1.1 PROJECT – H17-N136-CB

- A. COASTAL CAROLINA UNIVERSITY - JOHNSON AUDITORIUM RENOVATION 2022

ADDENDUM NO. 1

July 12, 2022

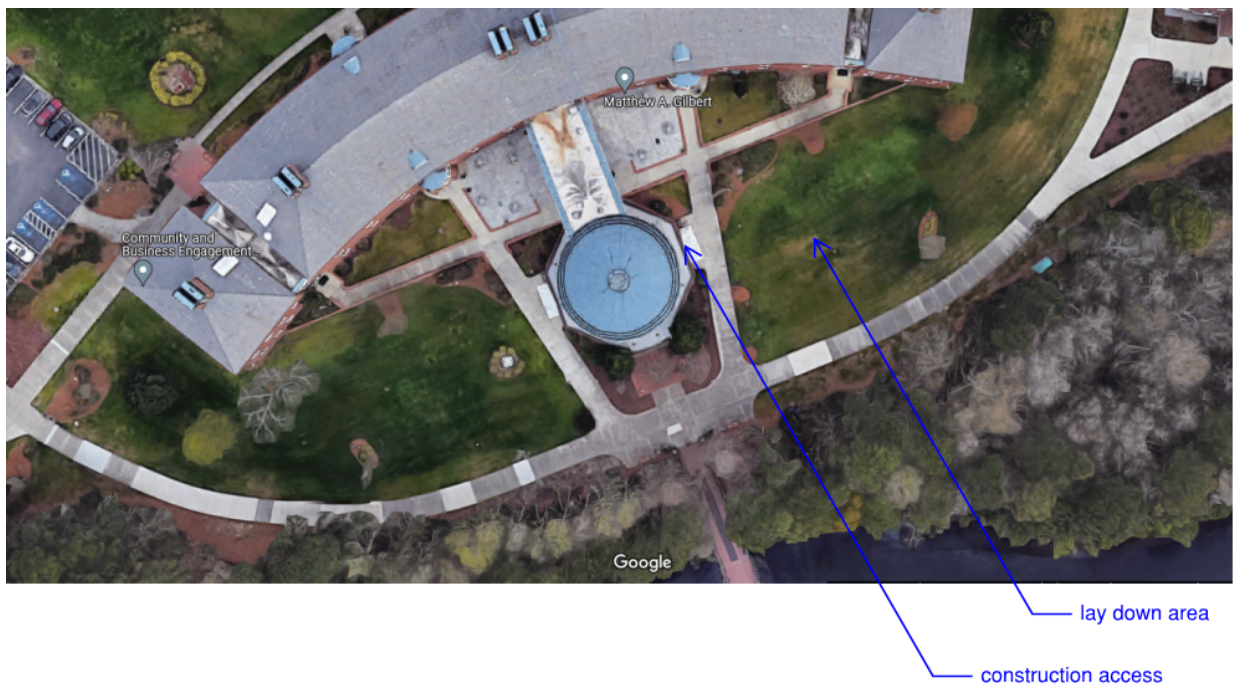
5. The specified structural concrete subfloor panel is not called for anywhere there is seating. These panels are shown for the subfloor of the AV booth only. It is simply a ¾" thick non-combustible subflooring panel. They should refer to Sheet A3.1. This sheet also shows the concrete slab called out for the ADA seating areas.
6. Due to current lead time concerns, a schedule will be coordinated with the contractor once lead times are identified. The project substantial completion shall occur no later than 3/15/2023.
7. See diagram below which shows potential lay down area and contractor access to the space.
